## Focus on Low-Activity Waste Treatment Alternatives

### Ecology's View

The Tank Closure & Waste Management Environmental Impact Statement (EIS) will support decisions for the final cleanup of much of the waste at Hanford -- the tank farms, the rest of the waste in the tanks, and the Fast Flux Test Facility.

Figure S-15 from the draft EIS summary.

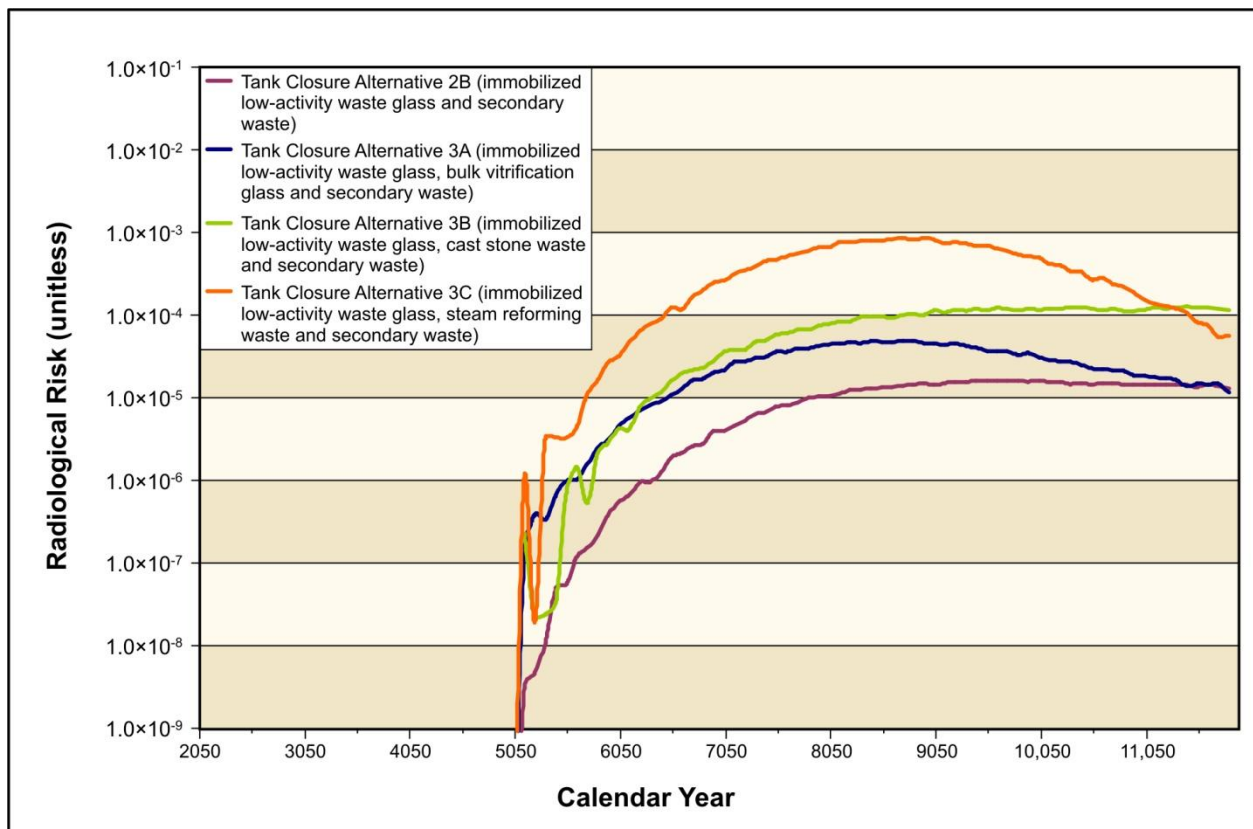
This figure compares the impact of the various waste treatment technologies combined with their secondary waste after disposal. This figure clearly shows why an all-vitrification option with robust mitigation of secondary waste is Ecology's preferred choice.
